Appl. No. 10/054,422
Amdt. dated June 8, 2005
Reply to Office action of Feb. 10, 2005

Amendments to the Drawings:

Fig. 1

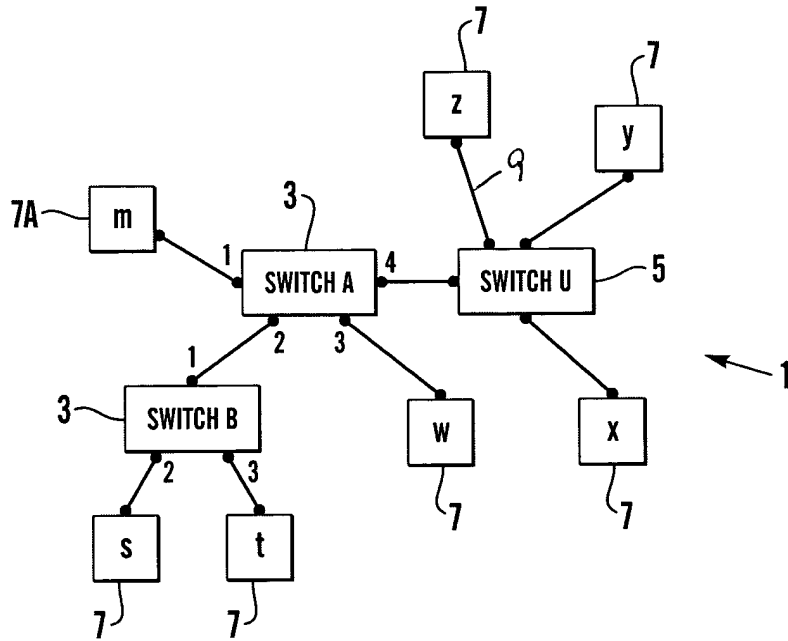
The attached sheet of drawings includes a change to Fig. 1. This sheet, which includes Fig. 1-2, replaces the original sheet including Fig. 1-2. In Figure 1, previously omitted reference numeral 9 has been added.

The Applicants have discovered that reference numeral 9 has been inadvertently omitted from Figure 1. To correct this error, the Applicants have enclosed a drawing sheet for this figure showing their proposed correction in red, as well as a substitute drawing sheet that contains this correction.

The Applicants now request entry of the substitute sheet.
